ADDENDUM NO. 2

RE: TENDER FOR SUPPLY OF CLOSING AND TRIPPING COILS FOR CIRCUIT BREAKERS AND UNINTERRUPTIBLE POWER SUPPLY (UPS) (TENDER NUMBER KETRACO/PT/028/2025-26)

*Tender Addendum and Clarification No. 2*

1. Close coil images

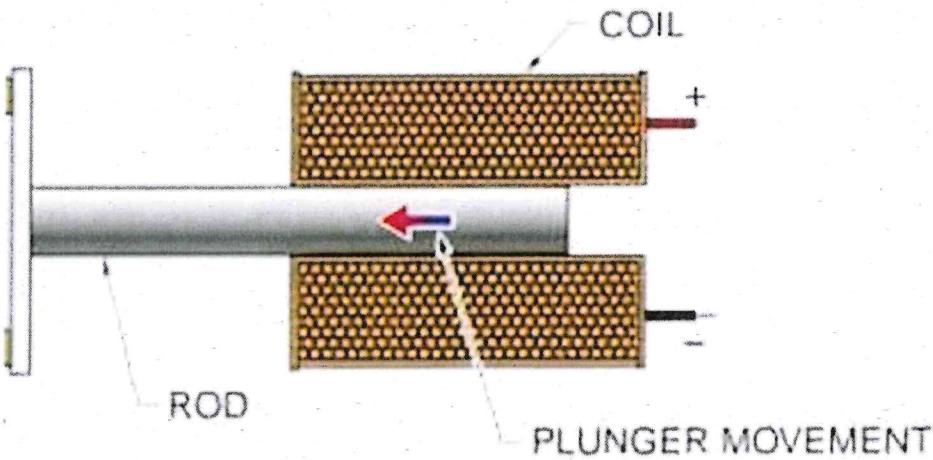
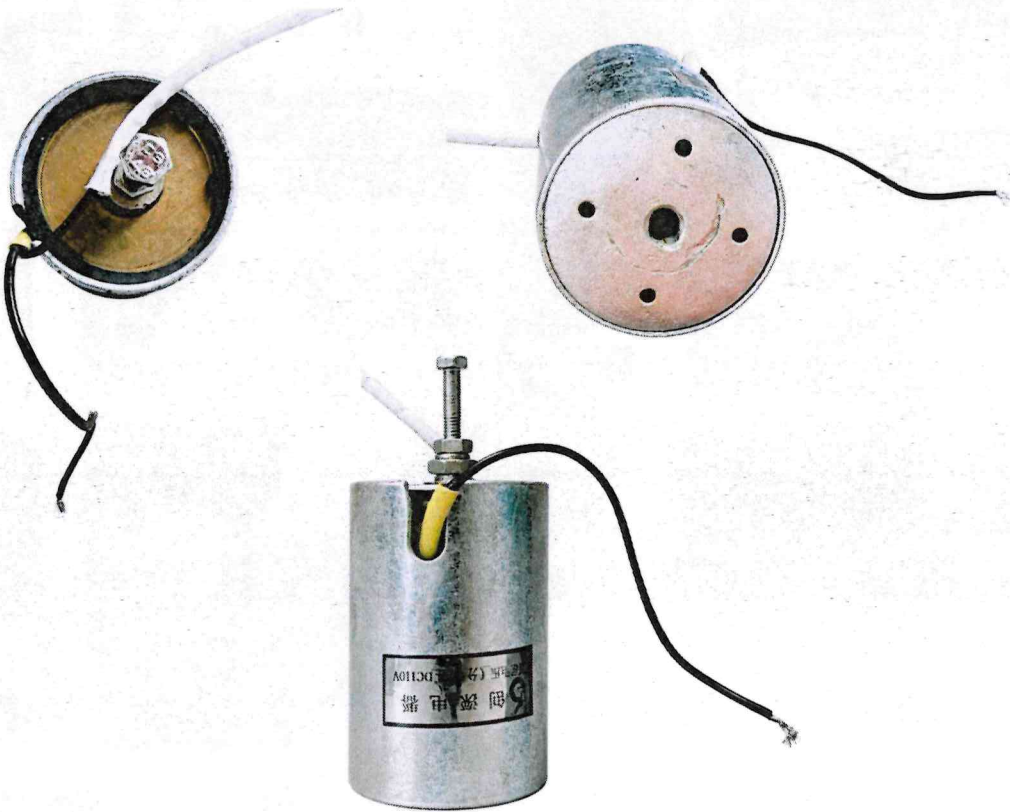
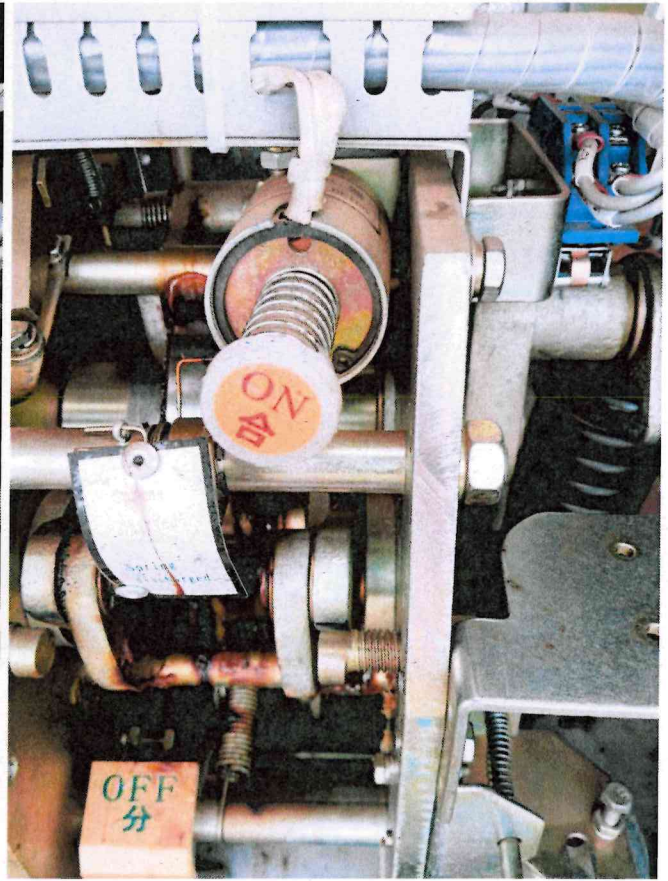
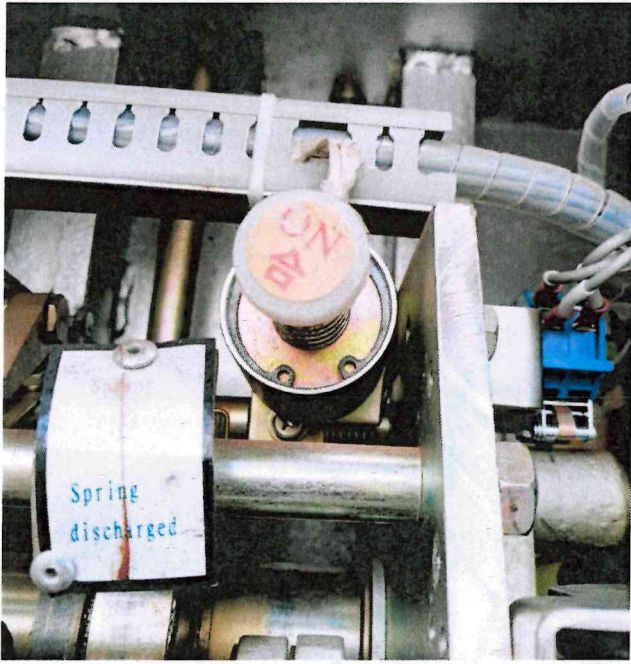
NO	BIDDERS CLARIFICATION	KETRACOS RESPONSE
1.	Clarification if an external battery pack is required for the UPS Units. Based on the specifications a standalone UPS will not be able to meet the required backup time of >30 minutes at 70% load	Based on the UPS design, an external battery pack can be provided to meet the requirement
2.	Ketraco to provide Photos or Diagram of the Closing and Tripping coils	Photos of the closing and tripping coils attached
